**COMMENT ON THE HYDROGEOLOGY OF  
PROPOSED CADIZ PROJECT**

**Prepared on behalf of**

**CENTER FOR BIOLOGICAL DIVERSITY &  
NATIONAL PARKS CONSERVATION ASSOCIATION**

**March 4, 2012**

Figure 1. Adjustments to BCM recharge estimates (Heilwell and Brooks, 2010--USGS).

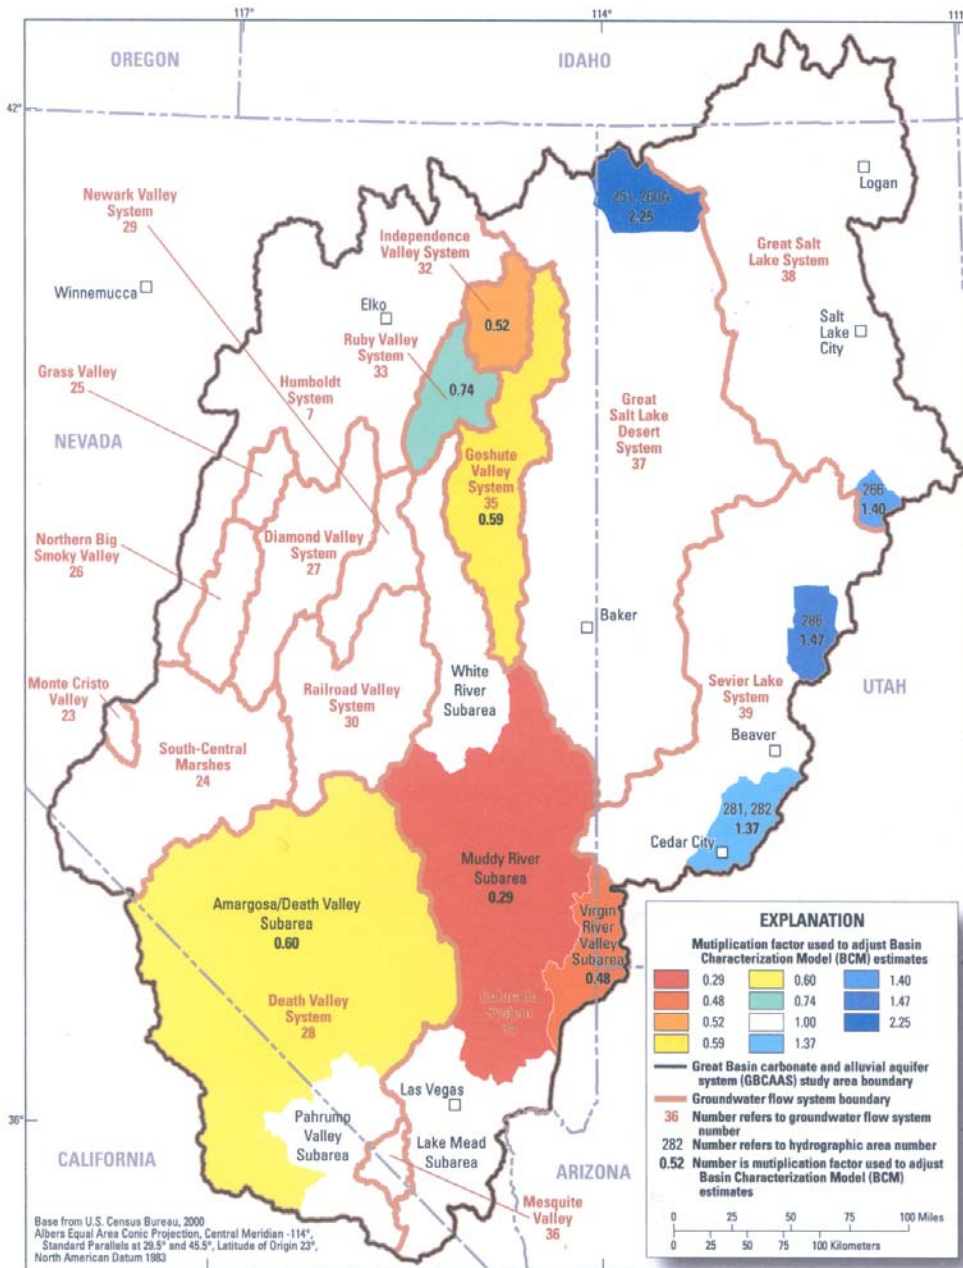
One sees in this figure that in many of the Nevada/Utah basins that the BCM calculated recharge values were reduced significantly. This emphasizes the importance of comparing recharge with discharge estimates, and their need to be reconciled.

Figure 2. Plot of the cumulative distribution of hydraulic conductivity values for the Carbonate Aquifer of eastern Nevada and western Utah (Bredehoeft and King, 2010)

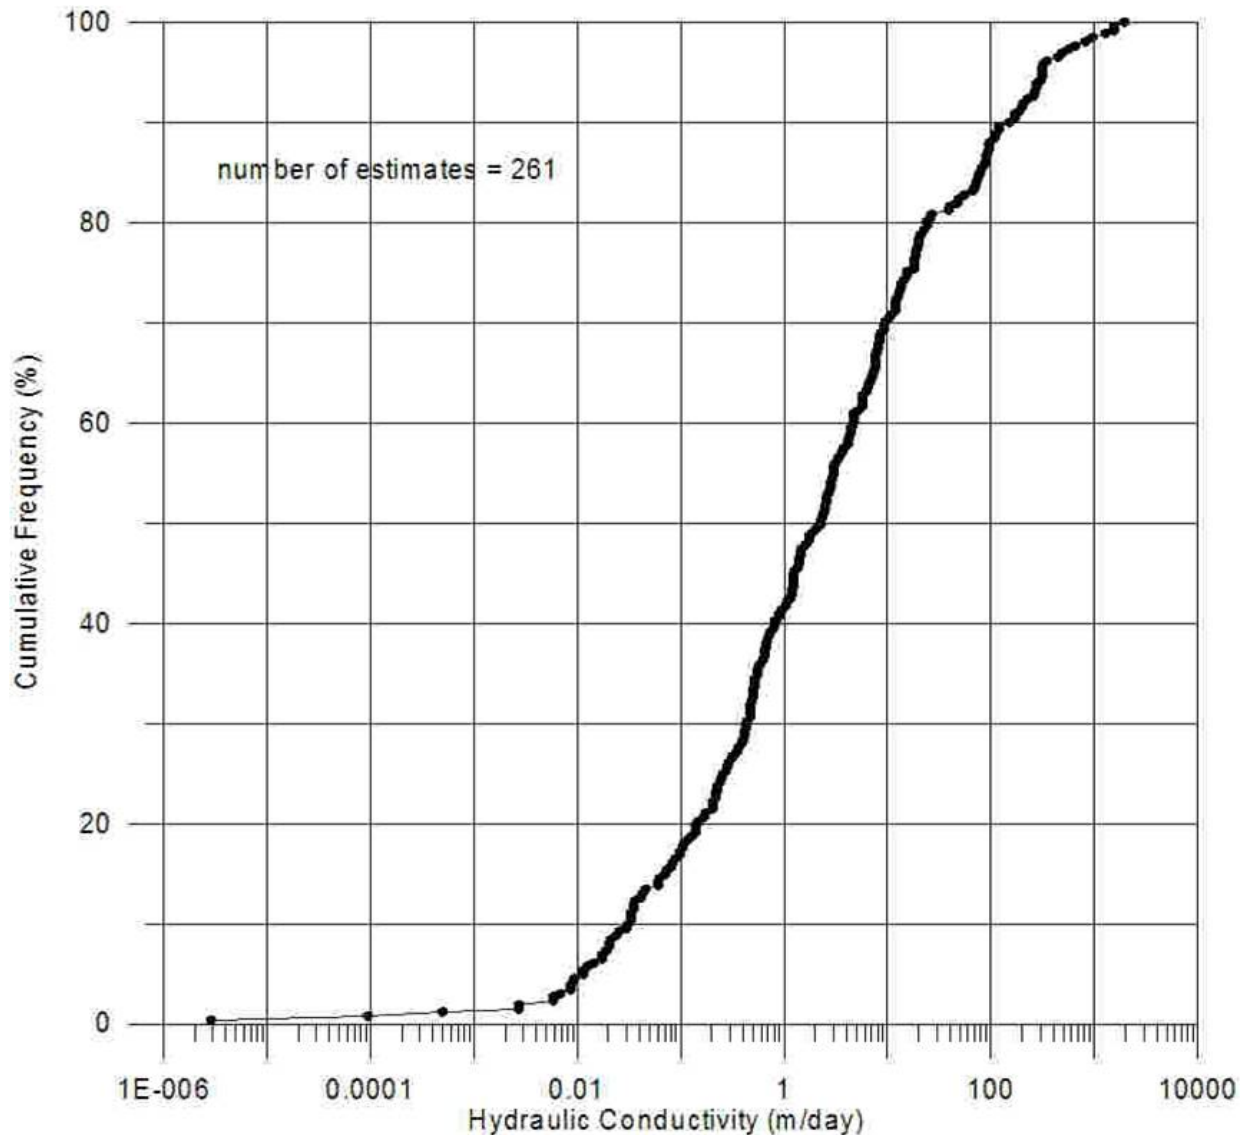
One sees in Figure 2 that a hydraulic conductivity value of 350 m/day (1150 ft/day) only occurs in wells in the Carbonate Aquifer of Nevada and Utah approximately 9 percent of the time—it is a high value. The CH2MHill model suggests that values in the range of 600 ft/day (approximately 180 m/day) are required for the carbonate rocks to achieve a good fit to the observed water levels. These values only occur approximately 10 percent of the time in the Nevada/Utah Carbonate Aquifer.

While the carbonate hydraulic conductivity values required by the CH2MHill model are possible, they are high.

Figure 4. Cumulative amount of groundwater removed from storage; from Geoscience (2011).

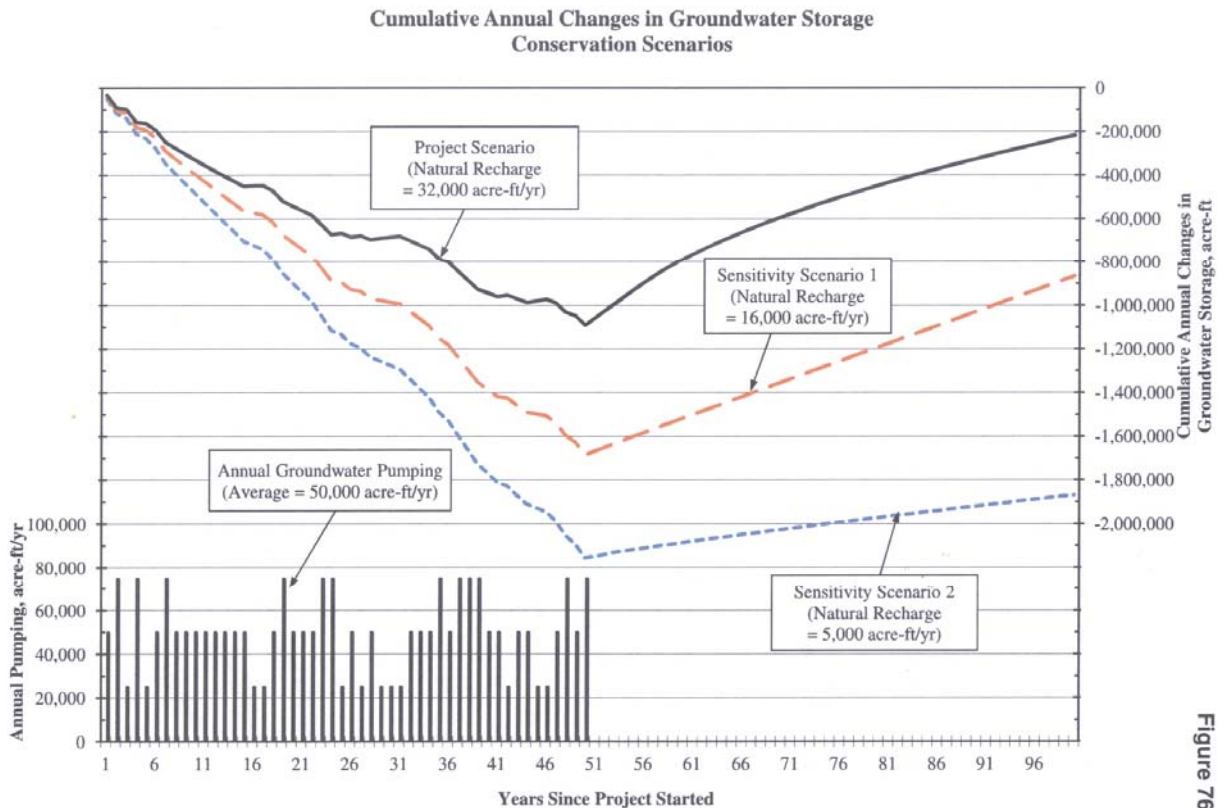
In Figure 4 the graph of the cumulate change in storage is a graph of the groundwater removed from storage needed to balance the pumping. As the recharge rate decreases the amount of water removed from storage must be larger to balance the pumping. This water removed from storage is groundwater that is mined from the system—it continues to declines as long as the pumping continues. In fairness, the Cadiz Project makes no pretense that it will not remove a large quantity from groundwater storage—i.e. *mine groundwater*.

My analysis suggests that the red or the blue curve (recharge of 16,000 or 5,000 ac-ft/yr) are probably more likely. This indicates that after 50 years of pumping between 1, 600,000 and 2,300,000 ac-ft of groundwater will be mined by the Cadiz project.

Once pumping stops the basin will recover, but at the lower rates of recharge it recovers slowly. With a recharge rate of 16,000 ac-ft/yr the basin is still depleted by 800,000 ac-ft 50 years after the pumping ceases; at a recharge rate of 5,000 ac-ft/yr the basin is depleted by 1,800,000 ac-ft 50 years after the pumping ceases.
